**Project #19-031
Kearl Property
1136 N 600 W**

Project Name: Kearl Property
Proponent/Owner: Travis Taylor / Leanard C. Kearl Jr. Trust
Project Address: Approximate 1136 N 600 W
Request: Rezone from NR-6 to MR-9, Subdivision and Design Review Permit
Current Zoning: NR-6
Date of Hearing: September 12, 2019
Type of Action: Legislative, Quasi-Judicial
Submitted By: Aaron Smith, Planner II

PROJECT: MILL HOLLOW SUBDIVISION
SHEET TITLE: OVERALL UTILITIES PLAN

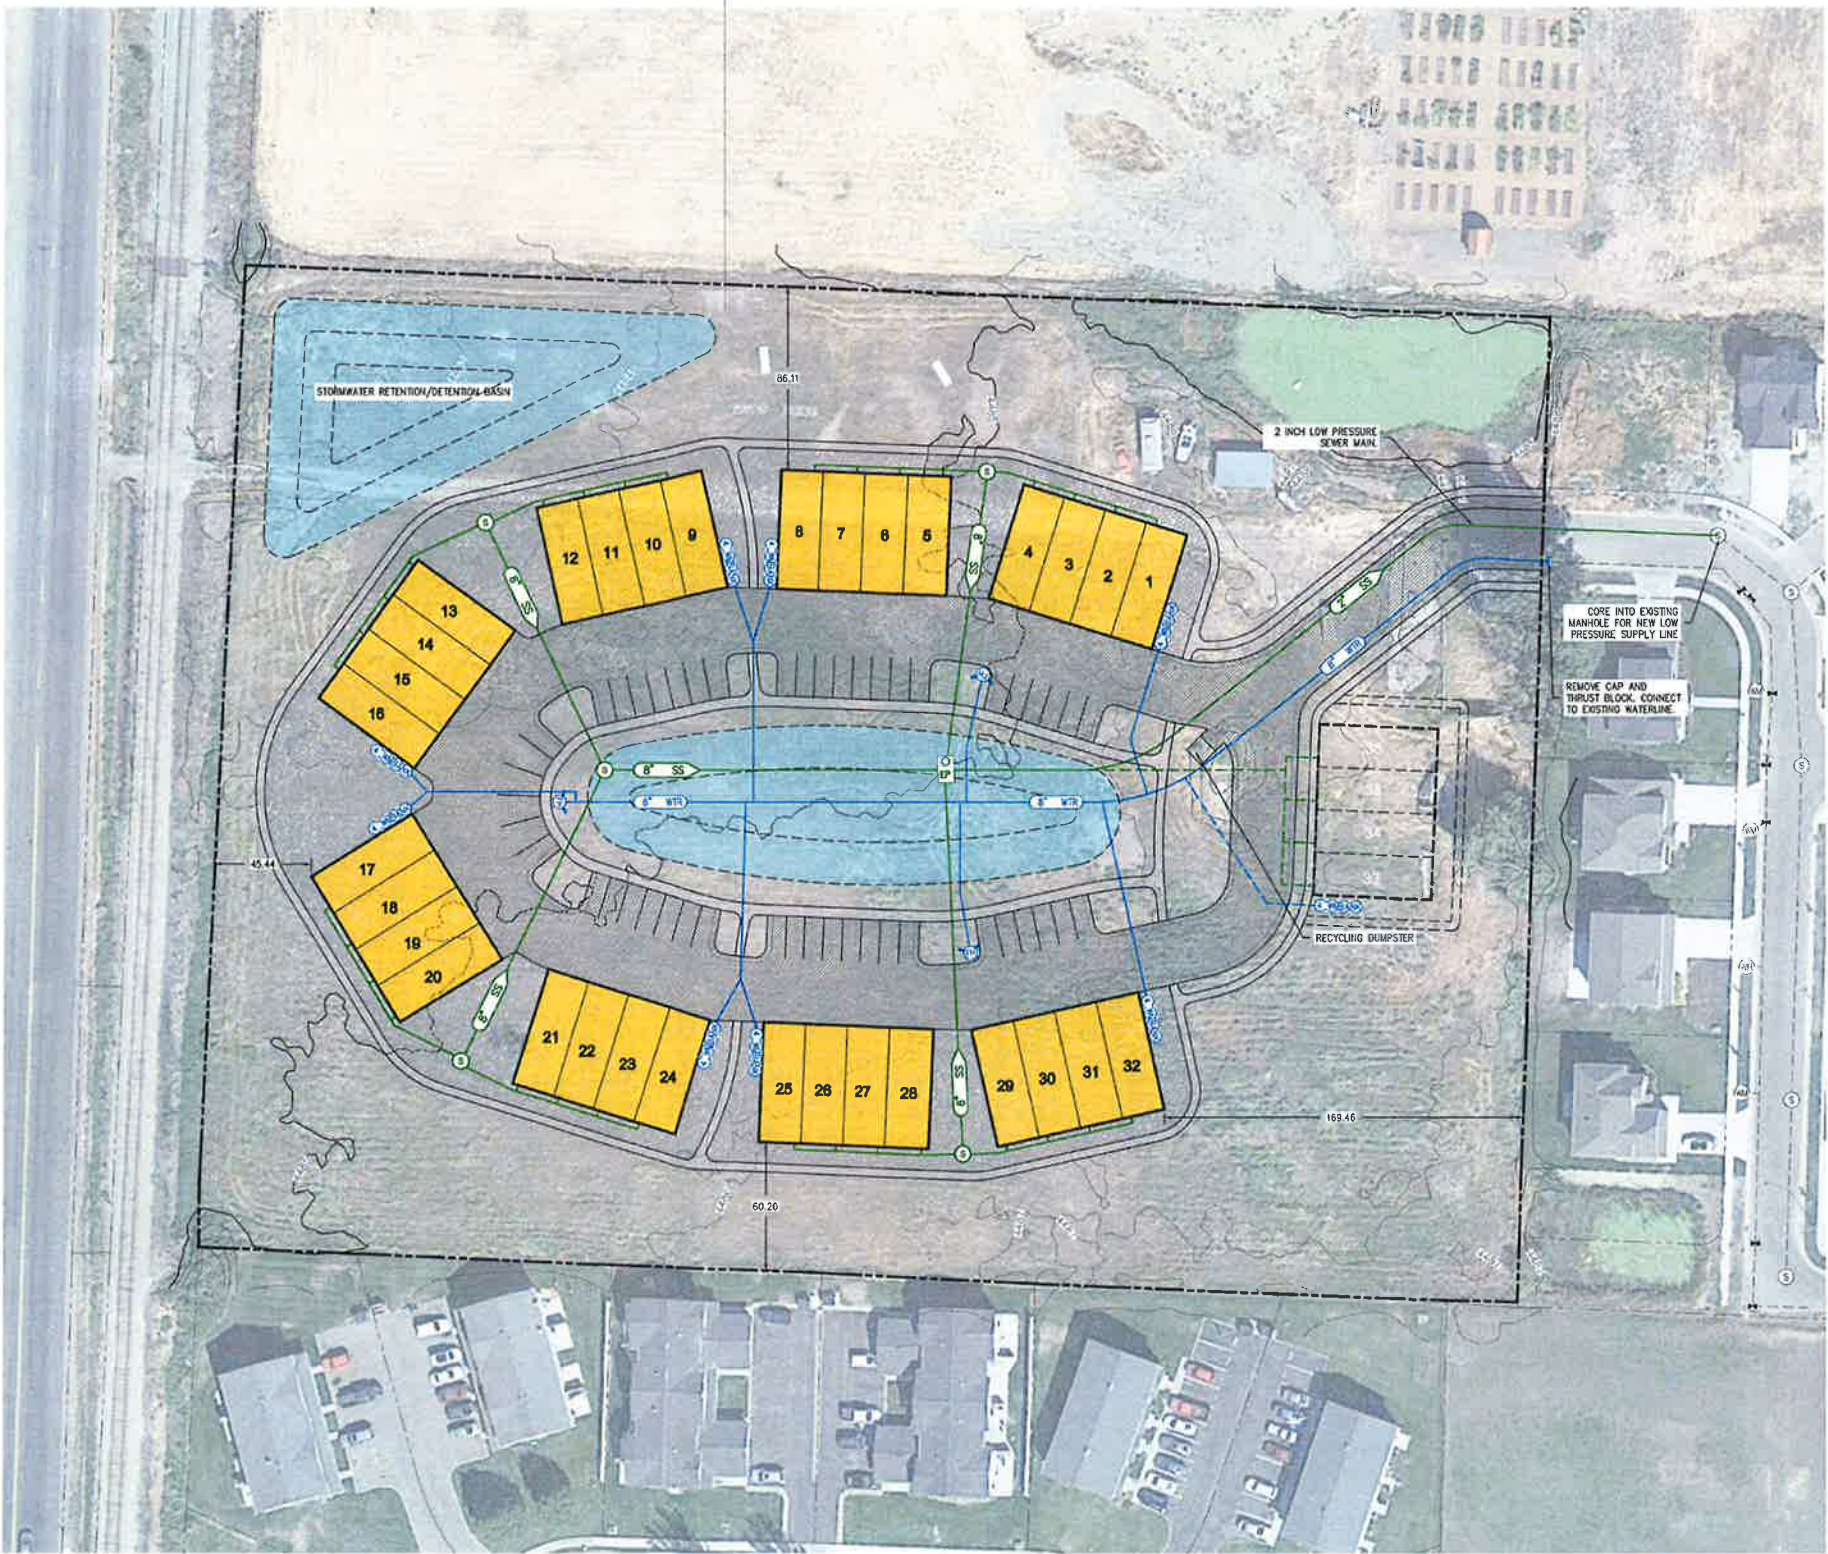
- a. *Water—contact 716-9622*
 - Water meter setters must meet current Logan City standards.
 - Any landscape irrigation systems that feed from City water must have high hazard backflow protection installed and tested. Either common or private.

- All current IPC rules for backflow protection shall apply during and after construction.
 - b. *Engineering – contact 716-9160*
 - Comply with City Storm Water Design Standards. This includes the on-site retention of the 90% storm event through the use of Low Impact Design practices. Area disturbed is greater than 1 acre, provide City with a Storm Water Pollution Prevention Plan

- Provide water shares or an in-lieu fee or all increased indoor and outdoor demands to existing system.
 - All buildings with 4 or less units per building shall have individual water services.

- No utilities can be placed under a storm water detention/retention pond.
 - Provide City with a private water utility agreement and a storm water maintenance agreement

- All roads as shown in development are not to a City standard and therefore shall be considered private.
 - All water and sewer services in this development shall be private.

- Second access to development for emergency purposes shall be provided.
 - Post the 33' drive through development as a Fire Lane.
 - c. *Fire – contact 716-9515*

- Developments of one or two-family dwellings where the number of dwelling units exceeds 30 shall be provided with two separate and approved fire apparatus access roads. Where two fire apparatus access roads are required they shall be placed a distance apart equal to not less than one-half of the length of the maximum overall diagonal dimension of the property or area to be served, measured in a straight line between accesses. IFC D107

- Fire apparatus access roads shall be 20 ft wide, signed as No Parking. IFC 503
 - Place fire hydrants so all points around the exterior of building are within 600 feet. IFC 507.5.1 Exception 1

SHEET TITLE
LANDSCAPE PLAN

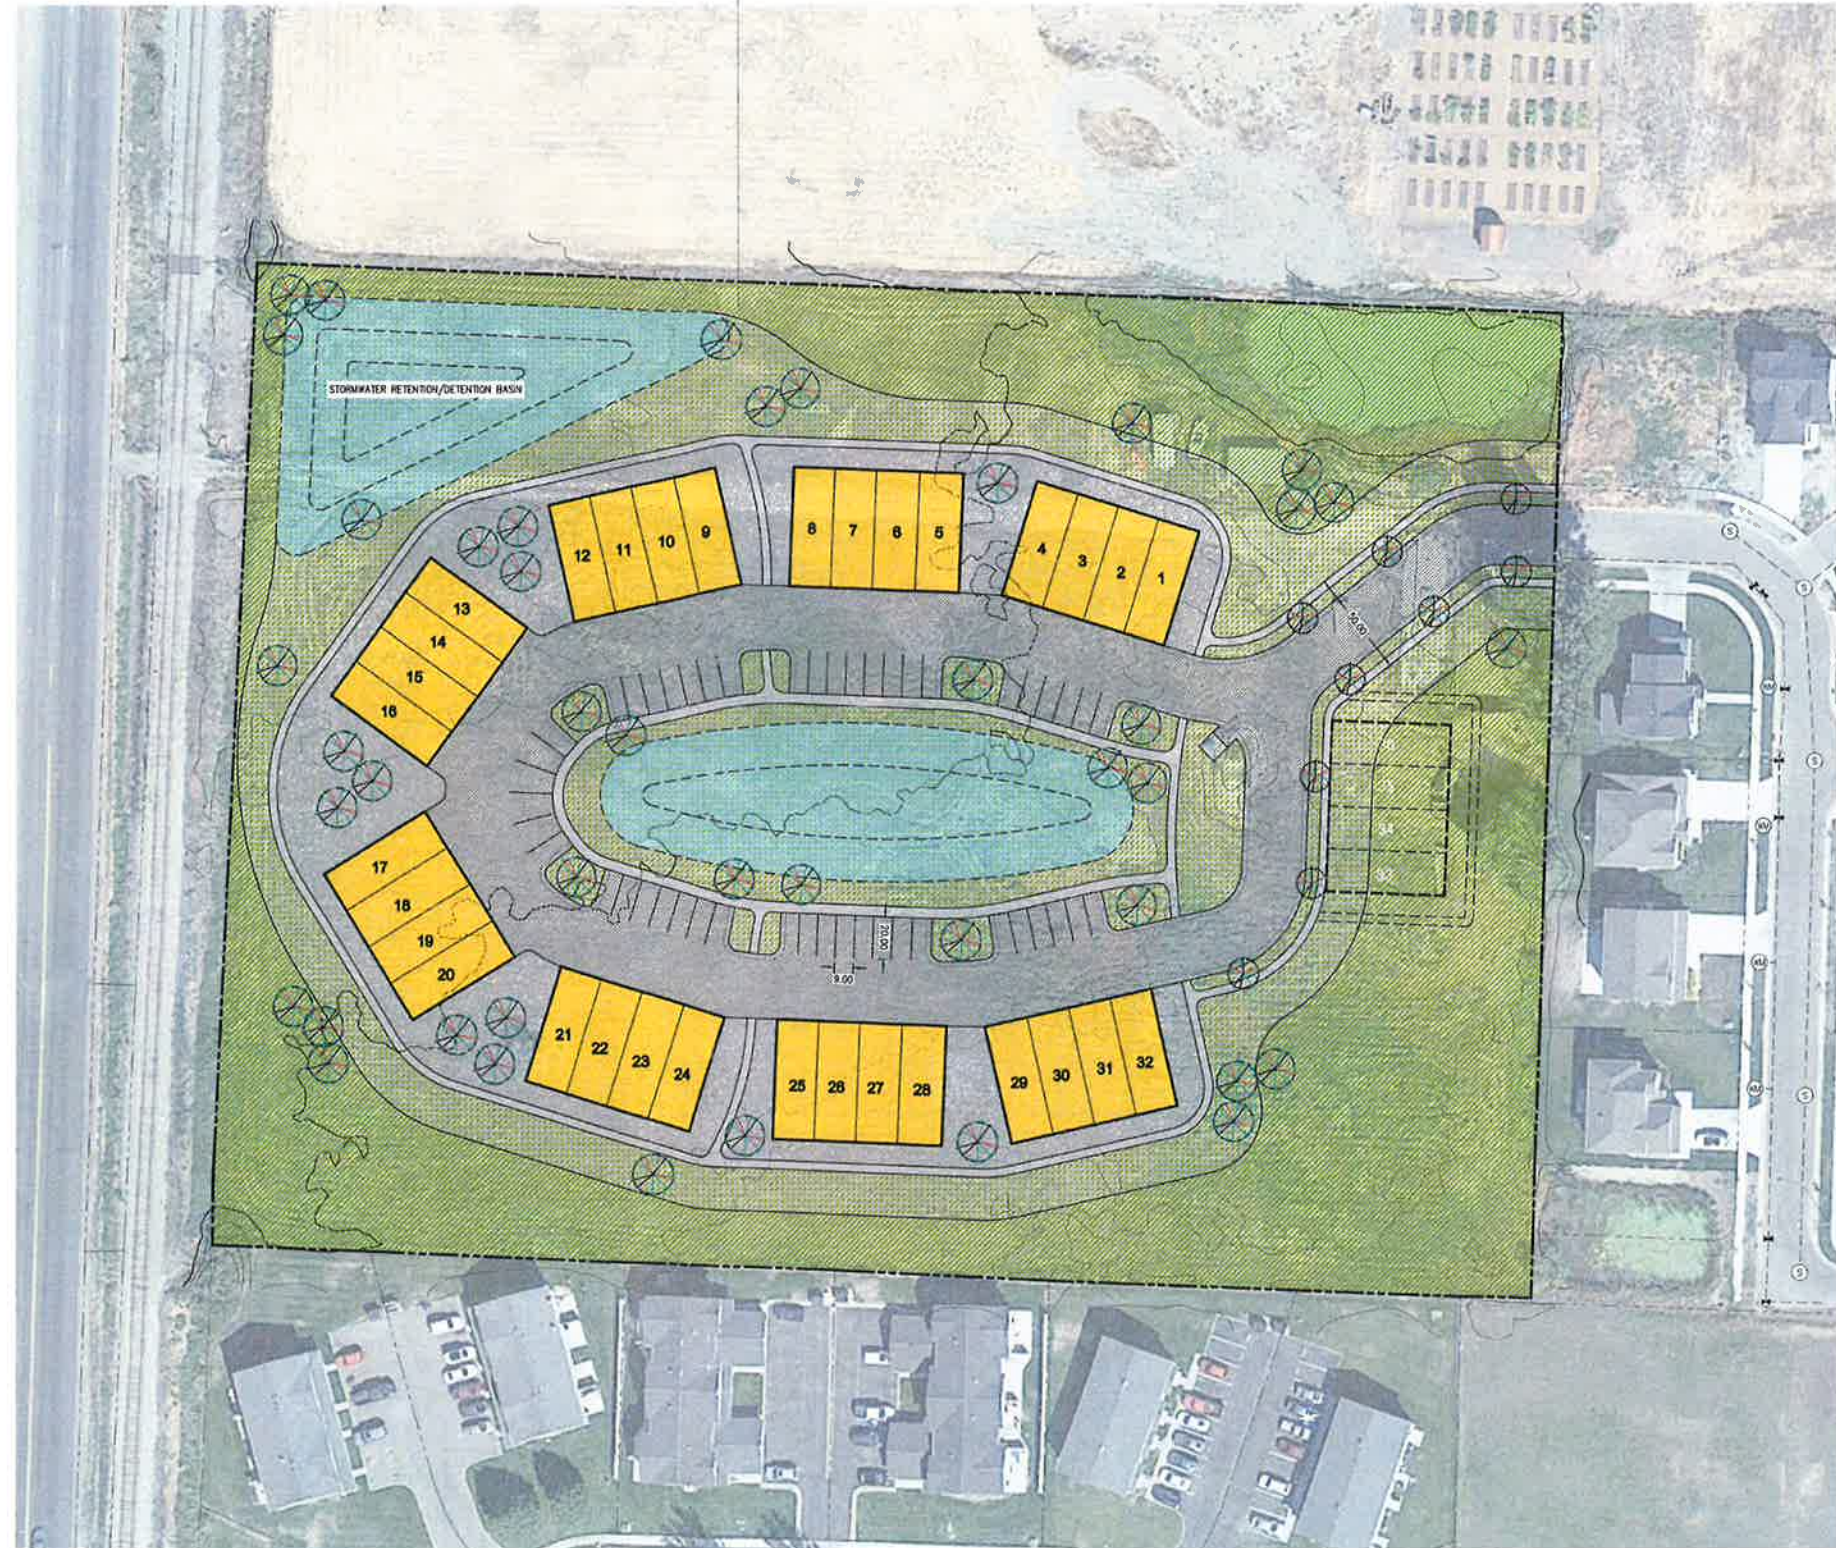
The LDC 17.32 requires minimum landscaping for overall visual aesthetics, ecological reasons, visual screening, shading purposes and enhancement of the outdoor experience. The LDC requires a minimum of 20 trees and a combination of 50 shrubs, flowers and ornamental grasses per acre of land in the MR-9 zone. For 6.55 acres, 131 trees and 328 shrubs, flowers and ornamental plants would be required as per the LDC. The proposed project shows conceptual landscaping area. The conceptual landscaping includes native grass planting around the edge, turf areas, and a gravel/xeriscape planting area around the homes. As conditioned

with a detailed landscaping plan meeting minimum plant numbers, that addresses plant type and management of native grass area, and provides street trees, the project complies with the LDC.

- b) 131 trees and 328 shrubs, flowers and ornamental plants.
 - c) Final landscape design shall indicate re-vegetation techniques for native planting areas.

- d) Street trees shall be planted every thirty (30) feet along all street and private drive that are not fronted by buildings or parking.
17. Storm water areas designed for open space shall be done in a manner that conceals the storm water function so that they generally appear as parks not storm water ponds.
